ADDENDUM NO. TWO  
NCSB -FBMS

To the Plans and Specifications for:  
Nassau County School Board – Project No. 98110-031  
Fernandina Beach Middle School Kitchen / Dining Remodeling and Campus  
Renovations/Enhancements

Date: October 16, 2018

FENCING PLAN  
FERNANDINA BEACH MIDDLE SCHOOL

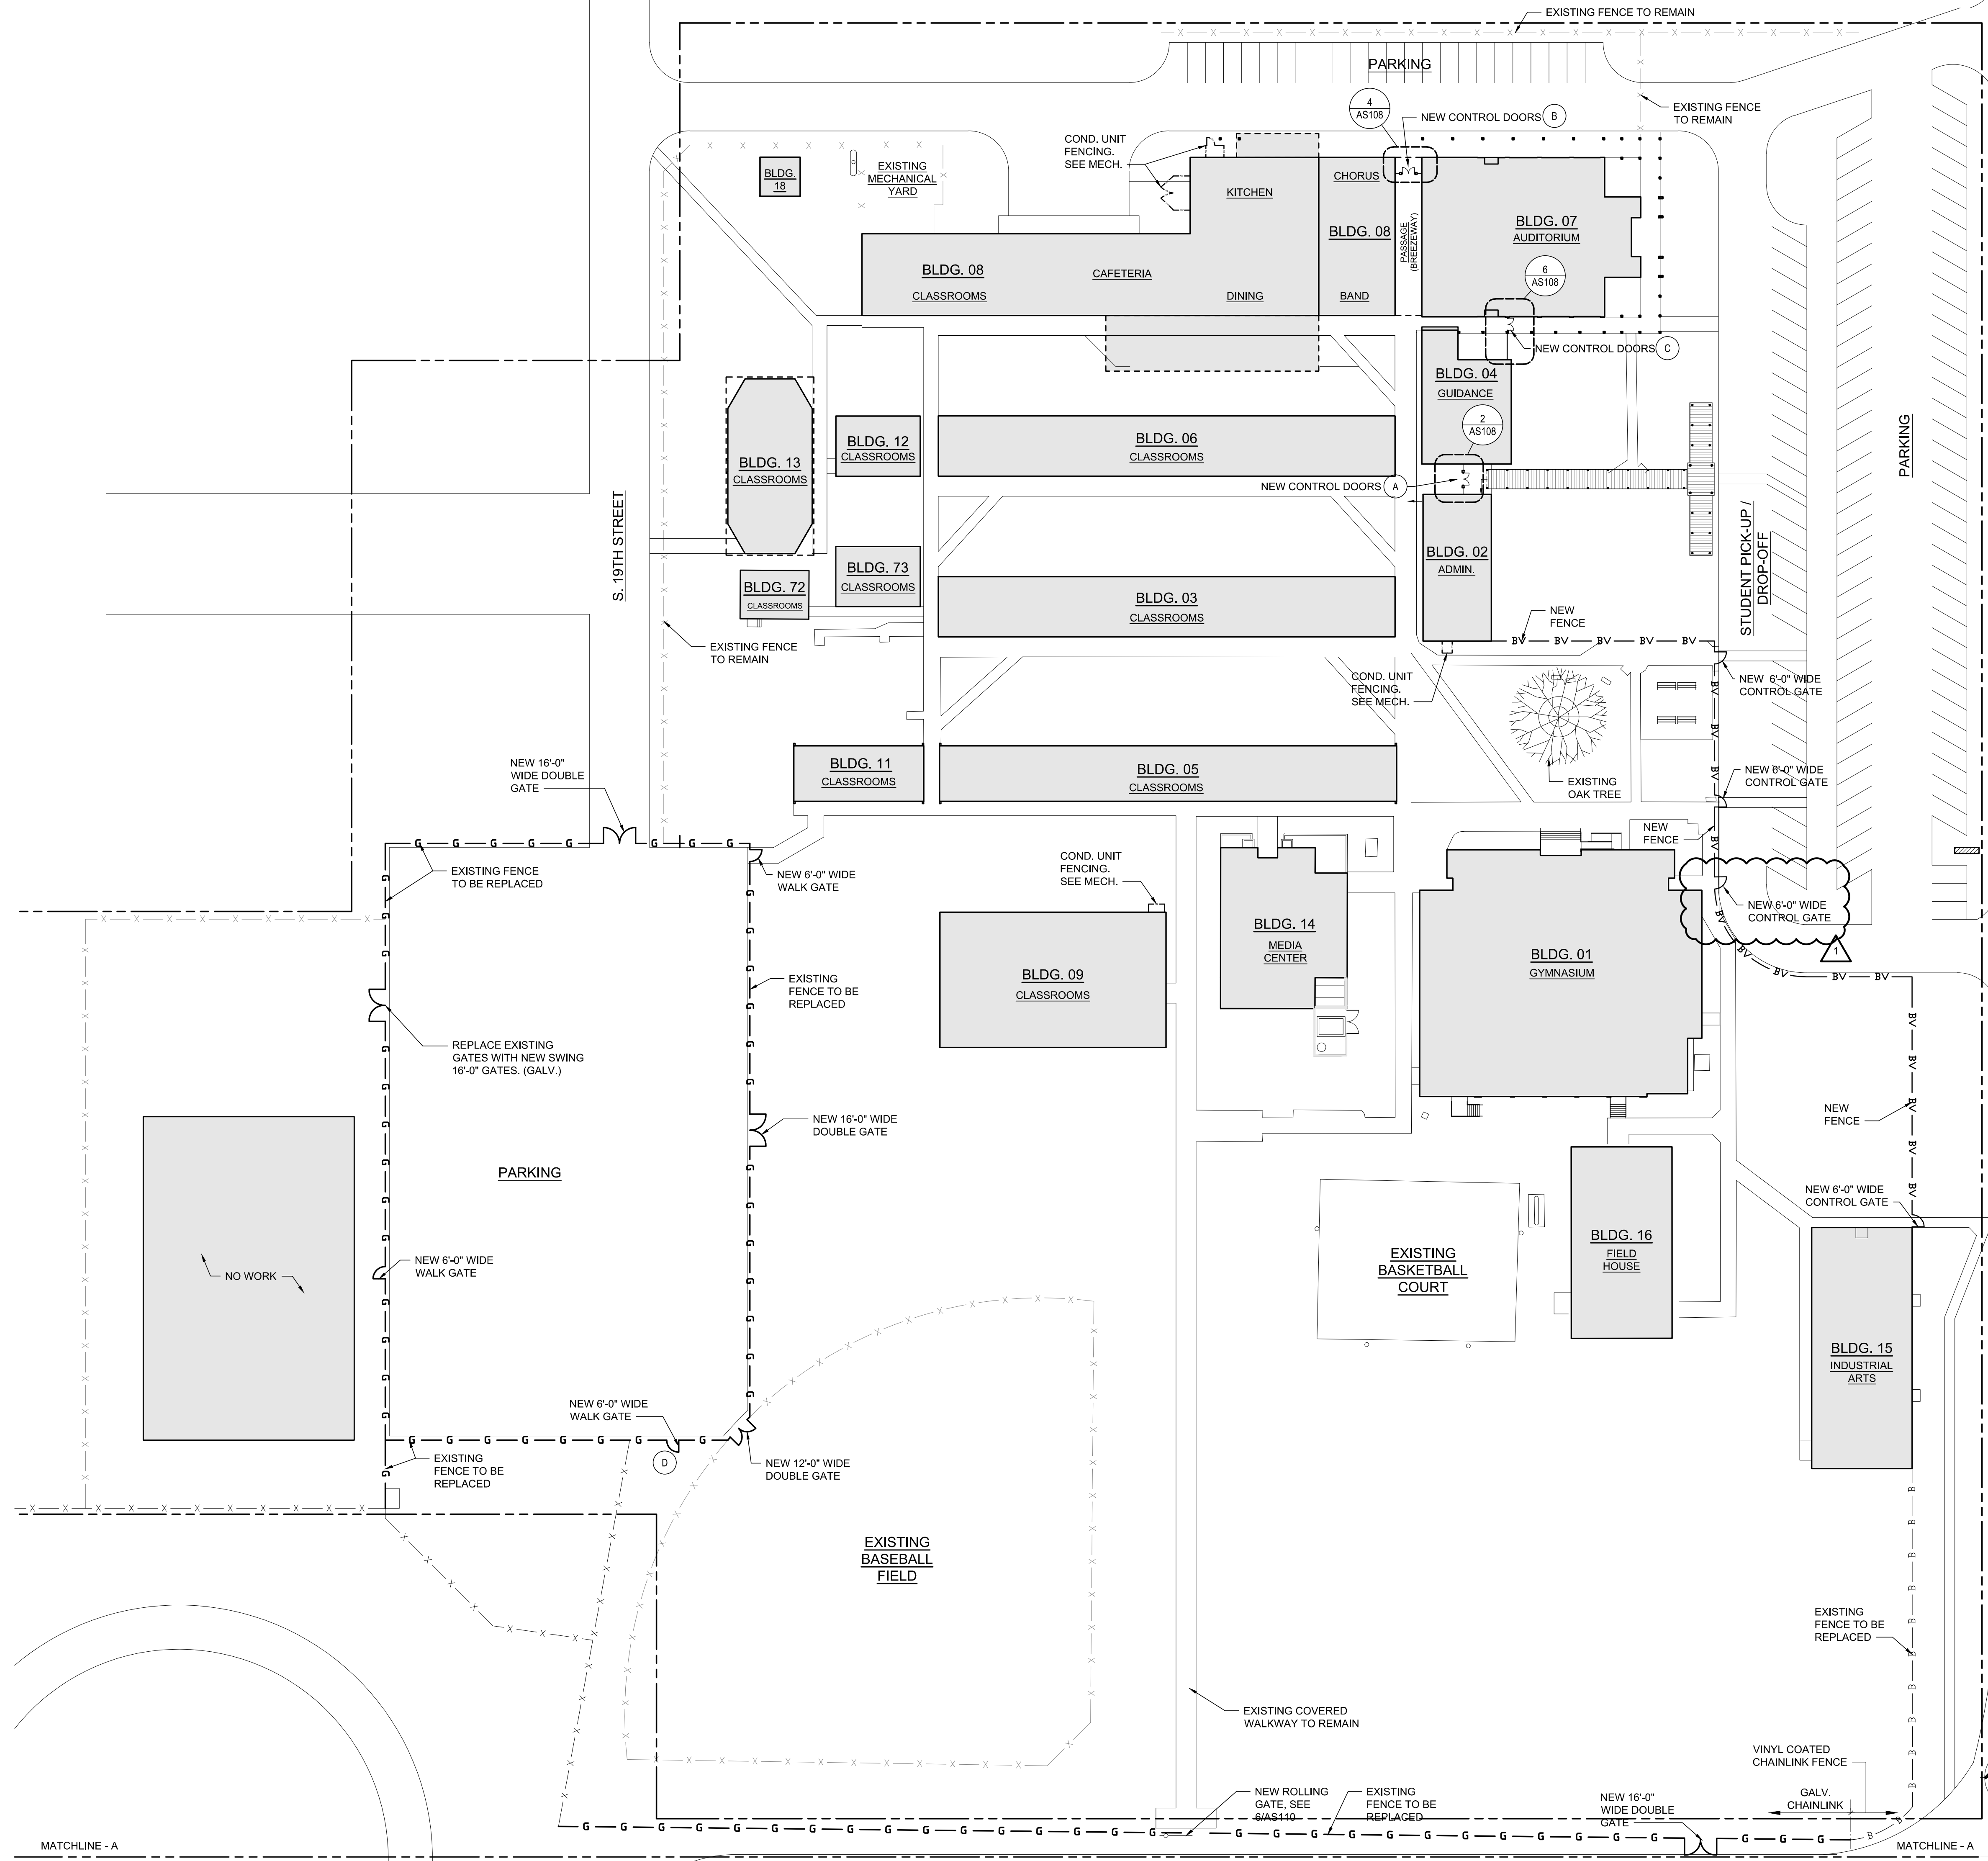
Refer to attached Sheet AS103 for changes to Architectural Drawings.
